STATE OF VERMONT
 DEPARTMENT OF HIGHWAYS

PROJECT FRASBURG-DERBY
 TOWN OF COVENTRY

ROUTE No. I-91 STA. 2683±
SA 3 OVER I-91

ABUTMENT #1
 SCALE AS NOTED
 IN CHARGE EDWARDS & KELCEY

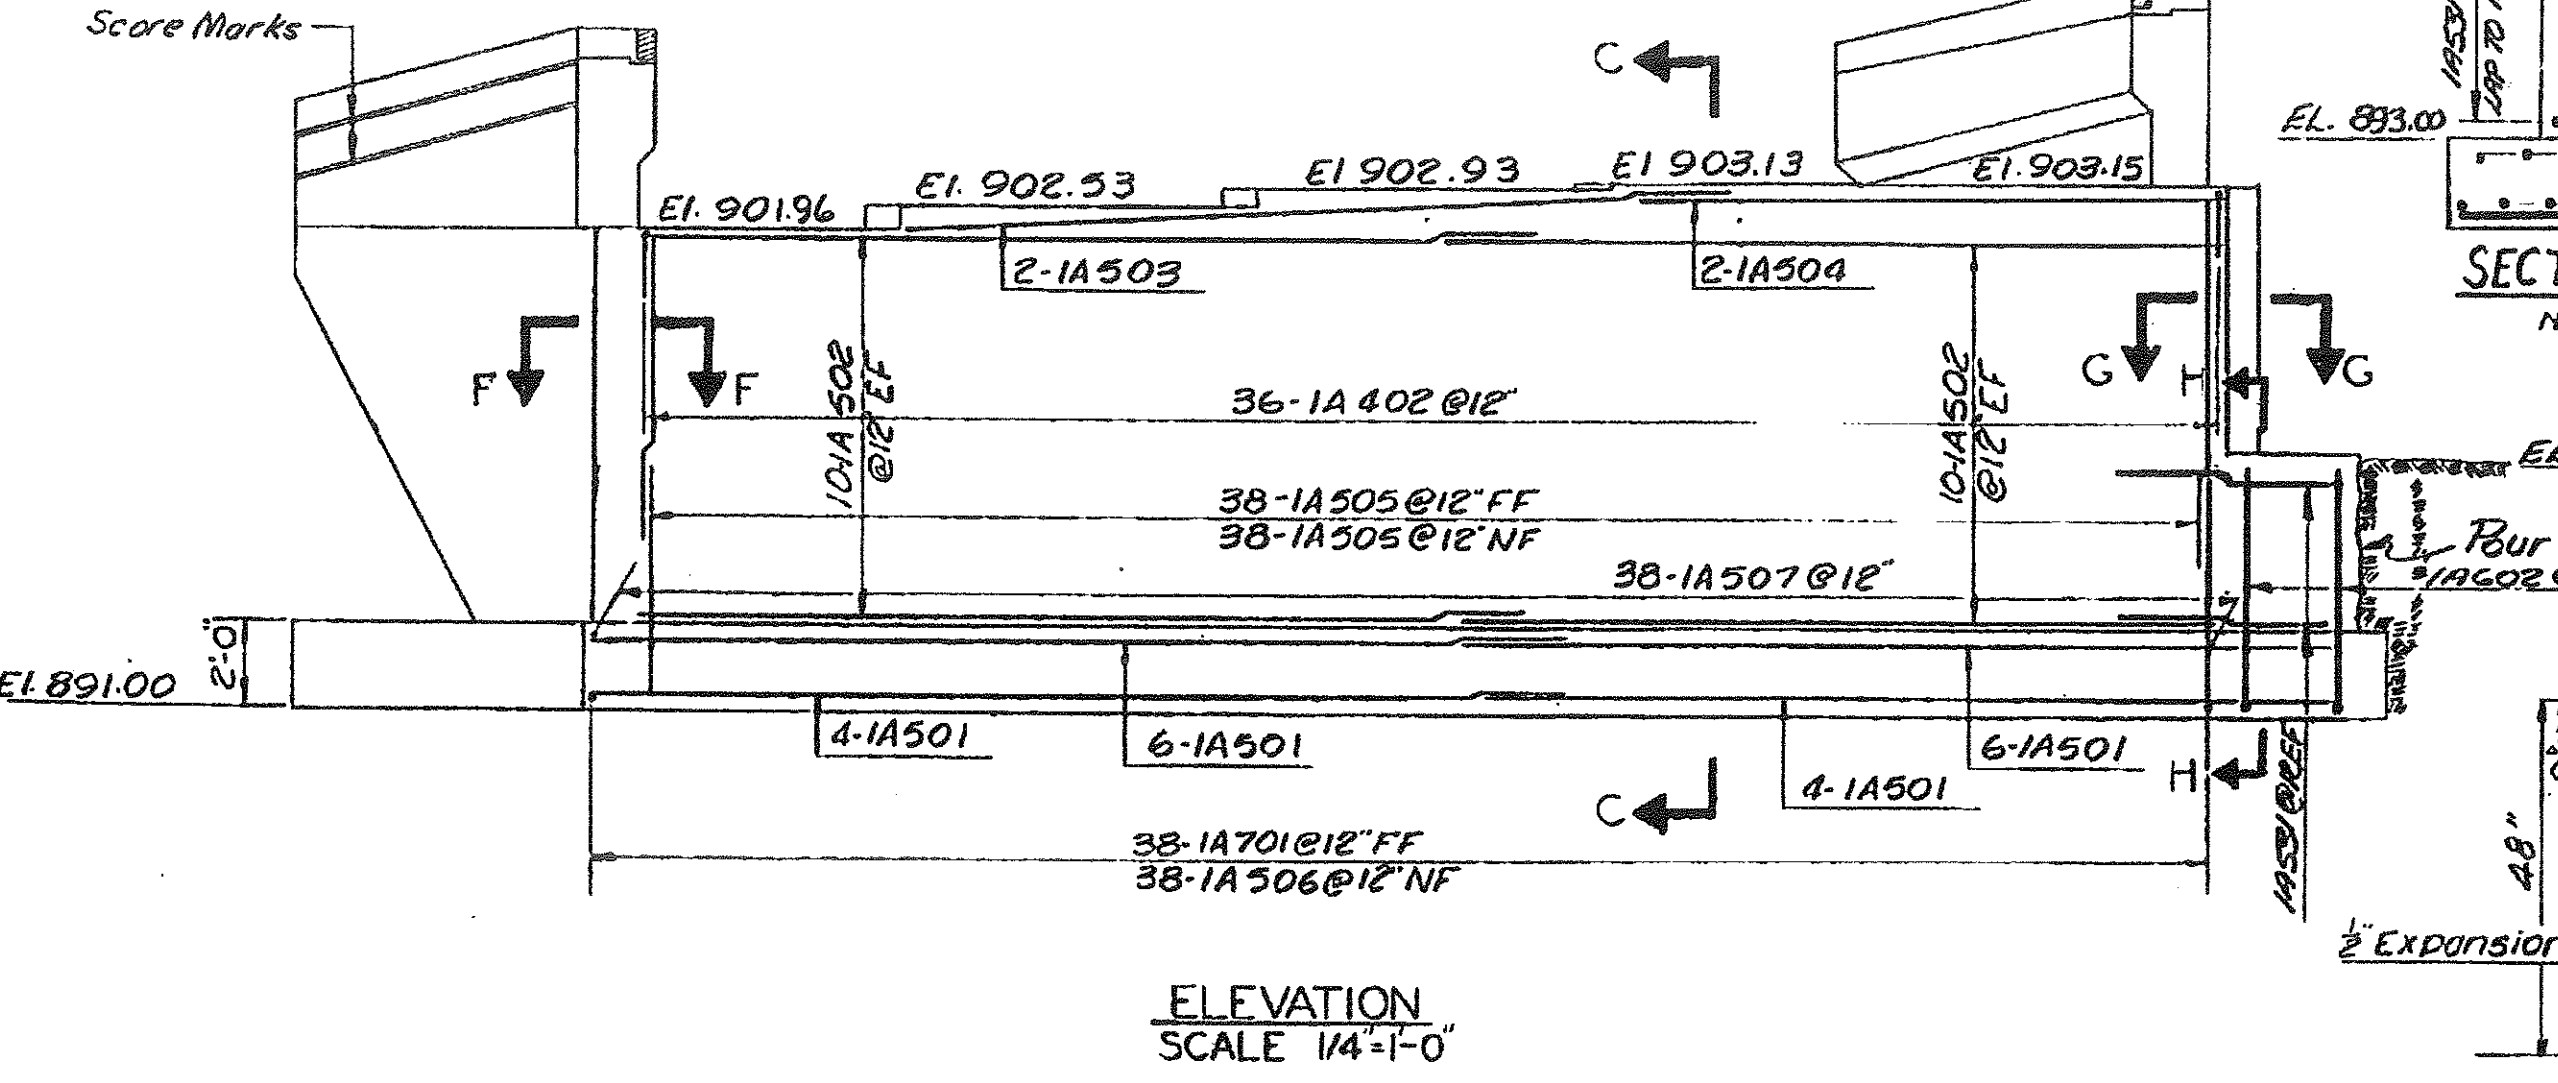
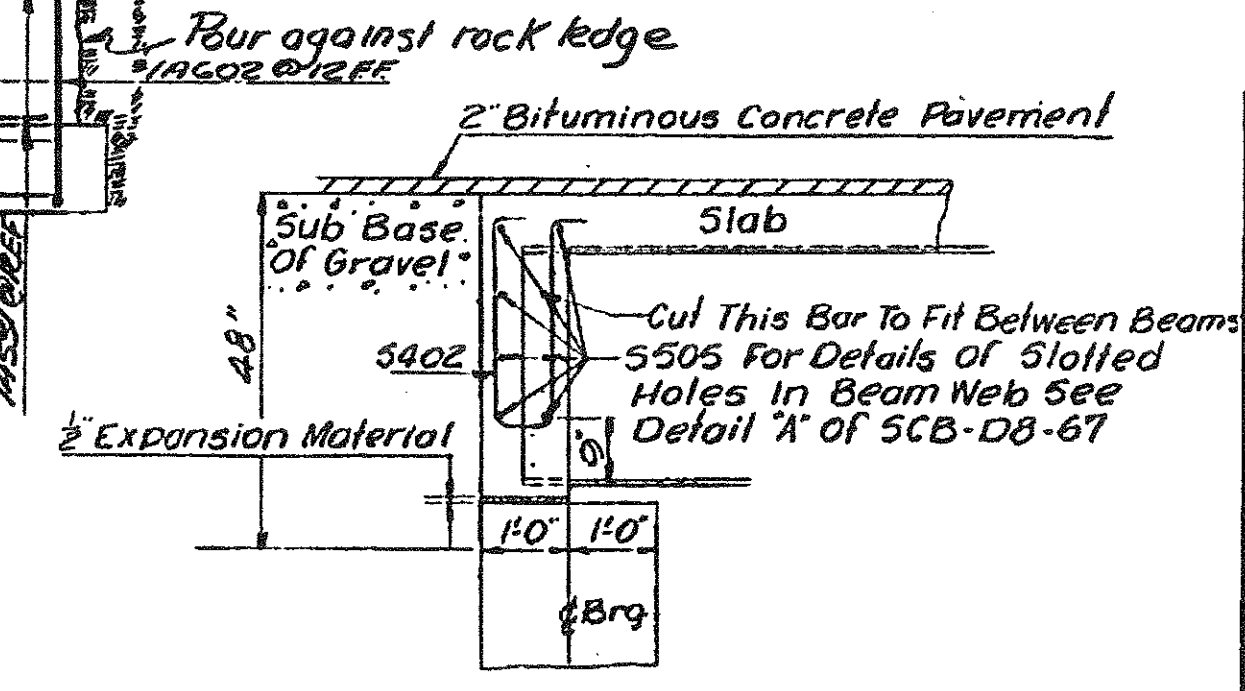
Changed Roadway Width from 30'-0" to 31'-4"; Curb Width from 2'-8" to 2'-0"
 Removed Closure Walls. Added Closure Wall
 Change Reinf. Steel Accordingly. Lowered Bridge Seal Elevations 1/2". (8/28/99)
